HISTORIC AND DESIGN REVIEW COMMISSION February 07, 2018

HDRC CASE NO: ADDRESS: LEGAL DESCRIPTION: ZONING: CITY COUNCIL DIST.: DISTRICT: APPLICANT: OWNER: TYPE OF WORK: APPLICATION RECEIVED:	 2017-588 814 BURNET ST NCB 549 (814 BURNET SUB'D {IDZ}), BLOCK 9 LOT 18 IDZ H 2 Dignowity Hill Historic District Felix Ziga/Ziga Architecture Studio Poma Properties, LLC Construction of four, two story, single family residential structures January 19, 2018
APPLICATION RECEIVED:	January 19, 2018
60-DAY REVIEW:	March 20, 2018

The applicant is requesting a Certificate of Appropriateness for approval to construct four, two story residential structures on the vacant lot at 814 Burnet.

SCALE: 3/16"=1'=0"

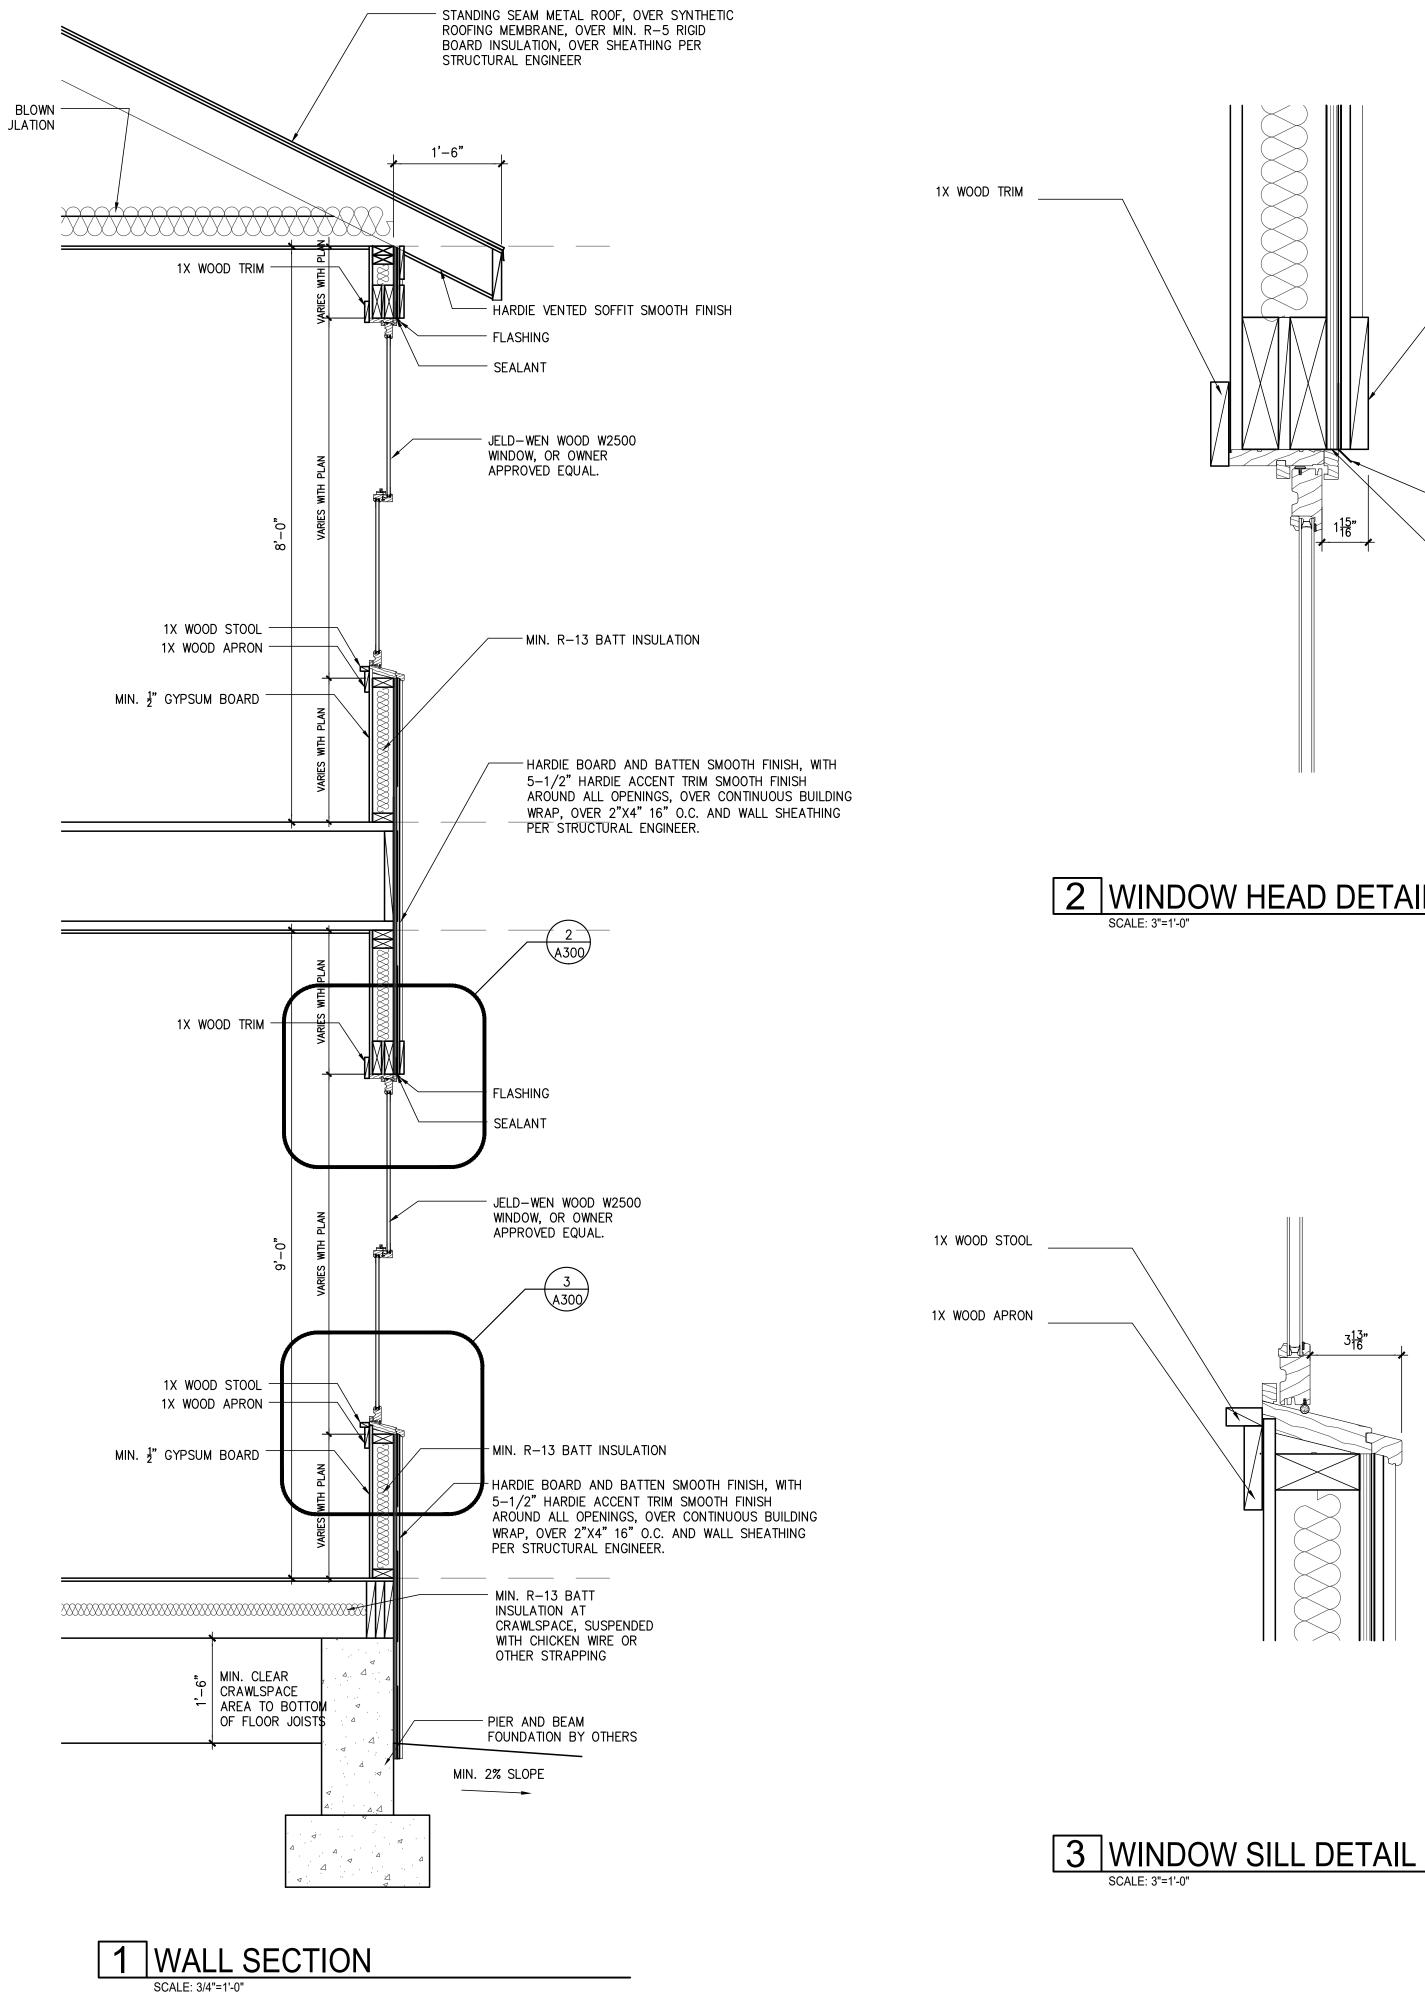
- n. ARCHITECTURAL DETAILS –Folk Victorian structures rely heavily on the relationship between front protruding window bays, side gables and inset porches. The front facing gable should extend to the top of the cross ridge line to present equal heights for both portions of the L plan. This has not been accomplished in unit 1. Additionally, porches on Folk Victorian structures are recessed behind the massing of protruding bays. As proposed, the applicant has proposed a porch that extends forward from the massing of the new construction. This is not architecturally appropriate. The front bay and gable should extend to the front of the porch massing.

- vii. That the structure proposed on lot 19 feature a front bay and gable that protrude further in order to meet to the

front of the front porch massing.
